ENGINE - LPT SHAFT - RELOCATE MARKING LOCATION OF SHAFT LENGTH - CATEGORY CODE 6 -
MOD.ENG-72-0049

V2500-ENG-72-0049

SERVICE BULLETIN

Marking Position of LP Turbine Shaft Length - Before and After Alteration
Fig.1

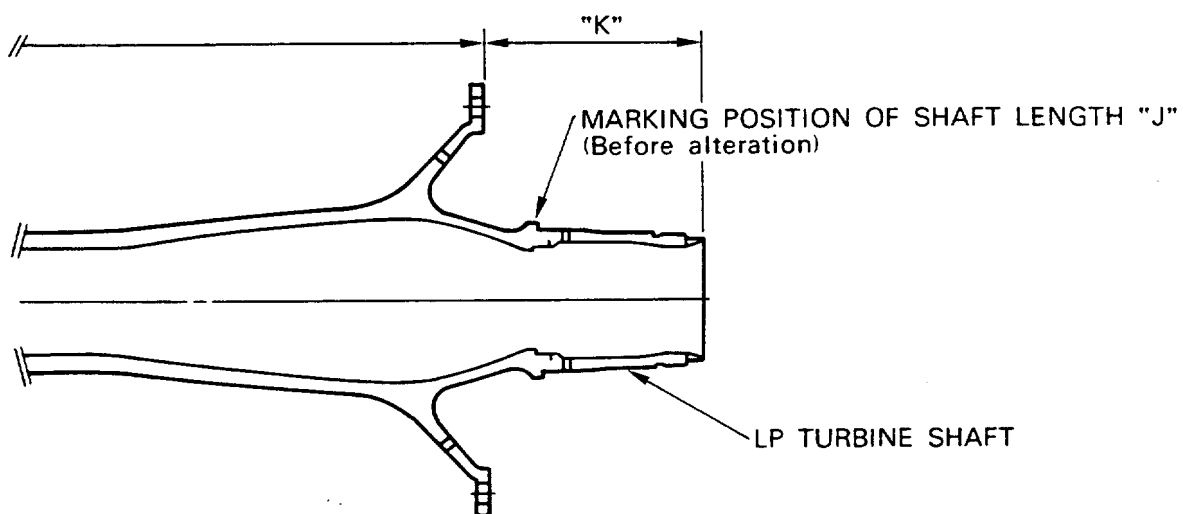
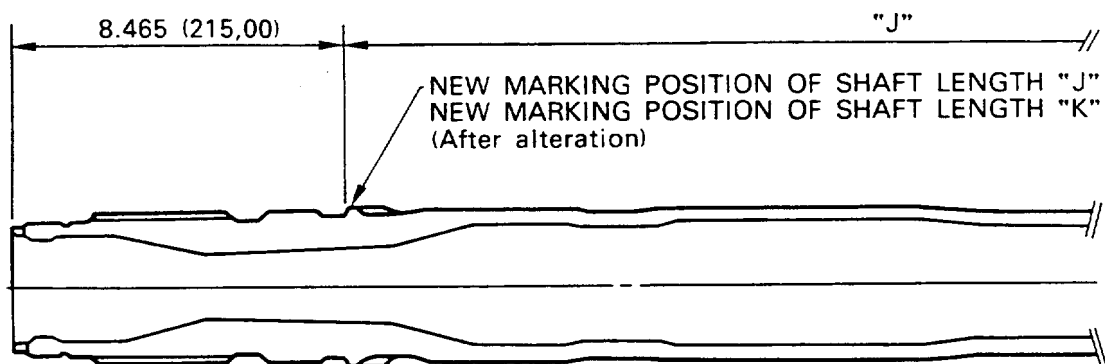
(a) The existing marking position of the LPT shaft length 'J' is relocated from the rear to the front of LPT Shaft (See Figure 1).

(b) A new mark of the LPT shaft length 'K' is written on the front of LPT Shaft adjacent to the new marking position of the LPT shaft length 'J' (See Figure 1).

- (1) Find the mark of LPT shaft length 'J' on the rear of LPT shaft where is written the shaft length with prefix L= and suffix MM (Refer to Figure 1).

- (2) Write a new mark of LPT shaft length 'J' which is a copy of the existing mark on the rear of LPT shaft with revised prefix from L= to J= on to the shoulder for adjusting ring on the LPT shaft by the vibro-peening method (Refer to Figure 1 and 1.K (2)).

- (3) Make the two lines on the existing mark of the LPT shaft length 'J' written on the rear of the LPT shaft to erase it with Vibro-peen (Refer to Figure 1 and 1.K.(2)).
- (4) Marking of the LPT shaft length 'K'
